14TH & REPUBLICAN

DRB RECOMMENDATION SUBMITTAL

DPD #3012837 FEBRUARY 6, 2013

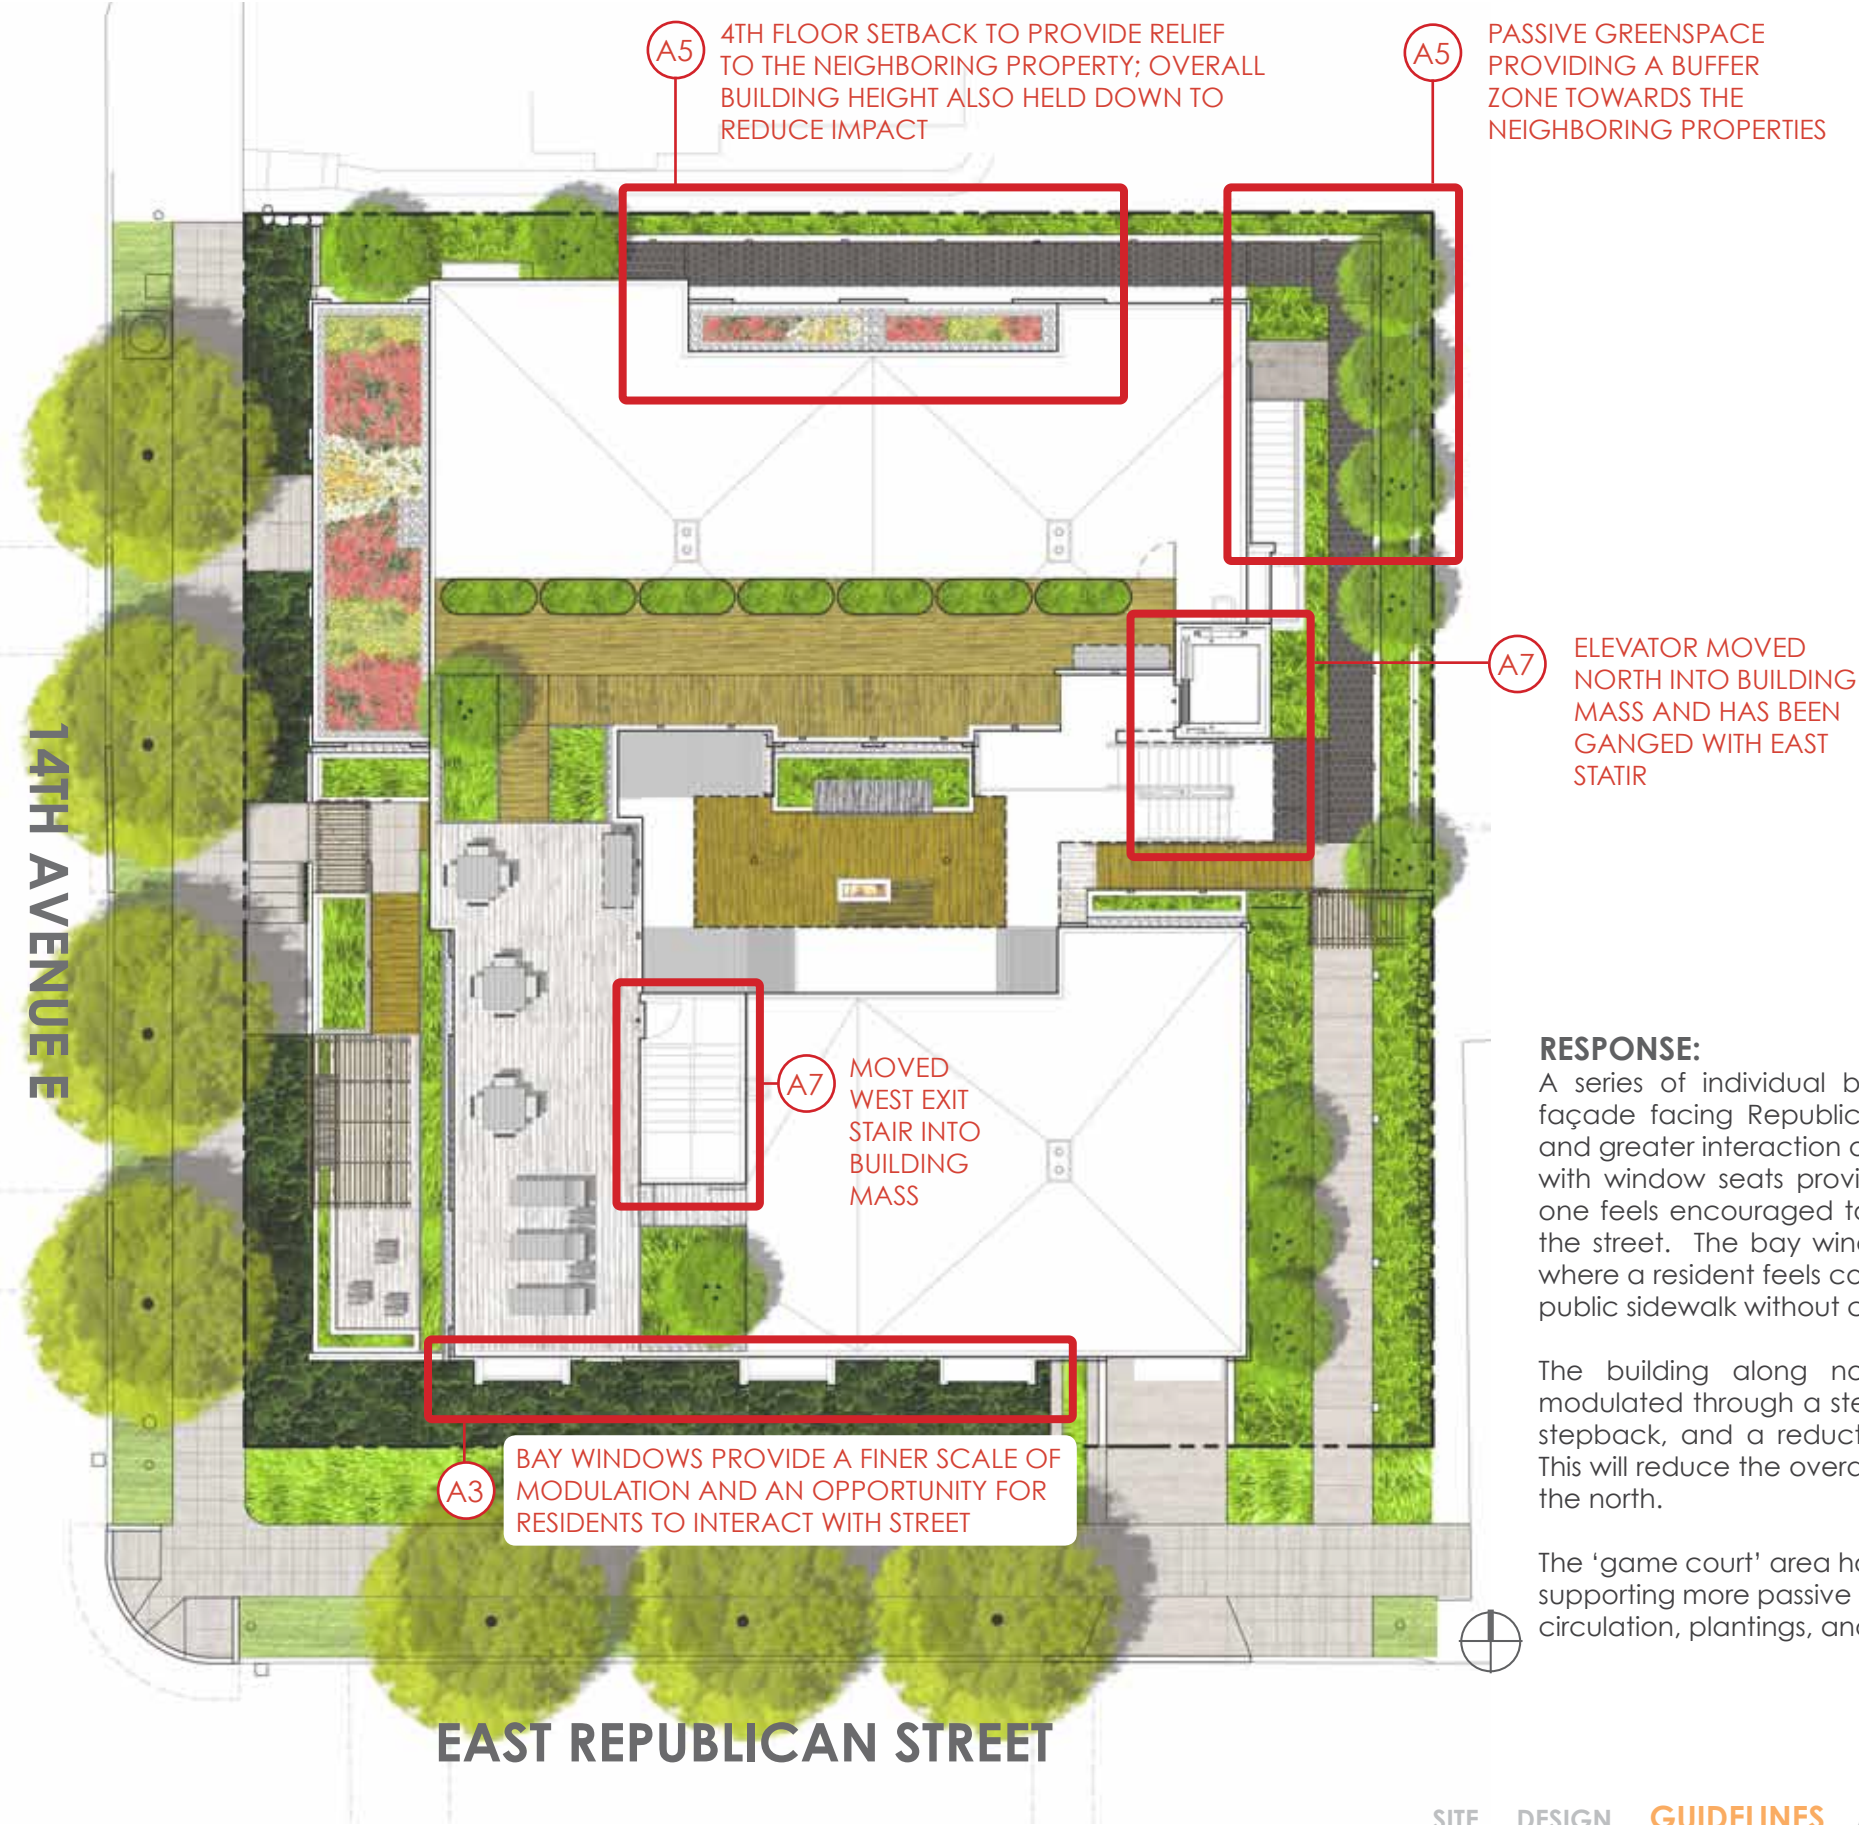
EDG Recommendations: The Board requests greater interaction between the proposed building and the E. Republican St. streetscape. Entrances and stoops would create a more active street front and begin to reduce the scale of the south façade.

EDG Recommendations: Noting the length and height of the north façade's impact upon the neighbors, the Board expressed its disinclination to grant the departure request related to this façade. Reconsideration of the departure would require greater setbacks and/or significant modification to the height and modulation of the wall. The Board asked for the game court area at the northeast corner to be reconsidered, providing passive landscaping to reduce noise impacts upon the neighbors.(see Guidance E-2)

A series of individual bay windows along the south façade facing Republican Street provide modulation and greater interaction at street level. The bay windows with window seats provide a substantial place where one feels encouraged to sit, read, lounge, and watch the street. The bay windows are placed at a height where a resident feels comfortable being seen from the public sidewalk without compromising privacy.

The building along north property line has been modulated through a stepping of the facade, 4th floor setback, and a reduction of overall building height. This will reduce the overall scale of the building towards the north.

The 'game court' area has been replaced with a space supporting more passive uses. The space is a balance of circulation, plantings, and seating. See Response E-2.

FIG 02: Sliding Cedar Screens in Open and Closed Position

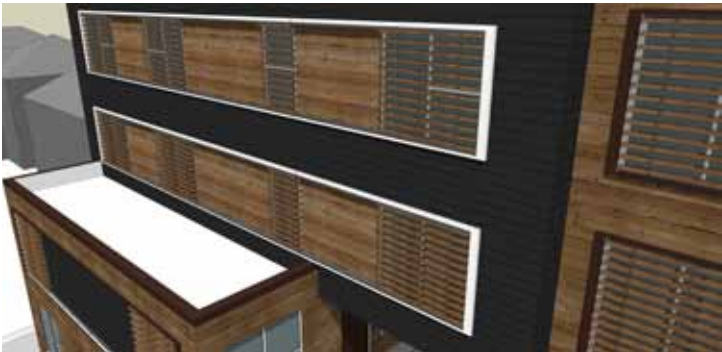
EDG Board Recommendation: Noting their appreciation for the architect's close analysis of the site's urban context, the Board responded with several observations. The larger apartment buildings in the neighborhood tend to be three or three and a half floors. The open entry portals shown on the context photographs are typically for vehicular parking and the pedestrian entrances telescope to a finer grain beyond the gate or portal.

The entry portal balances the needs of providing a pedestrian entry to the project while providing a proper view corridor through the site. The portal serves as a distinguishing element of the transition from public to private, providing a zone of compression that opens into the central courtyard. Incorporation of an entry gate and articulation of the ground plane with softscape and hardscape provides a finer of grain definition beyond the larger mass of the portal.

FIG 02: Garage Door Departure Sketch

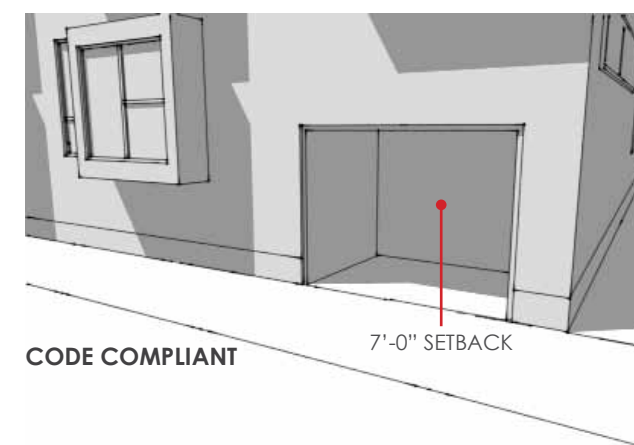
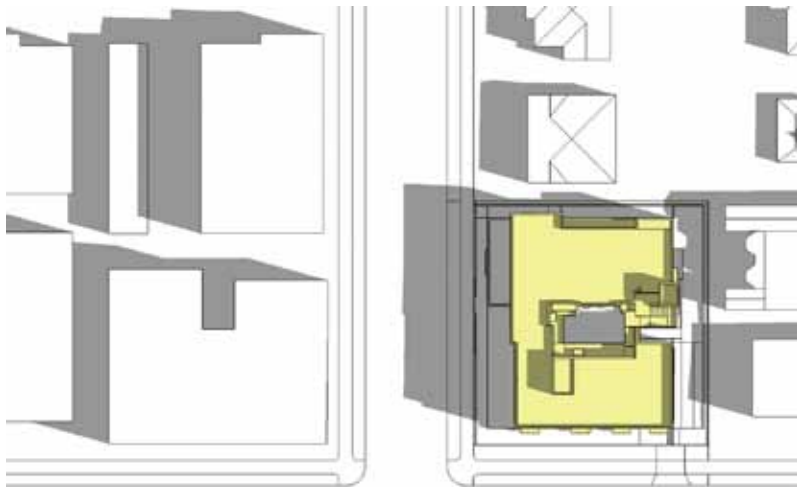
EDG Board Recommendation: The Board noted its likely support for the garage door departure request.

Place the garage door 7'-5" from the street lot line.

If the project garage door was located per code (SMC 23.45.536.D.3.b Screening of Parking by Garage Doors), it would be set back 7.5' from the face of the building to meet the 15' minimum setback. The proposed departure proposes locating the door along the building face, which is set back 14' from the back of sidewalk. This orientation promotes safety, as it would eliminate a 7.5' additional setback (recess) into the building and is architecturally consistent with adjacent garage access that is typically set flush with the building face. This departure allows the project to better meet the following design guidelines:
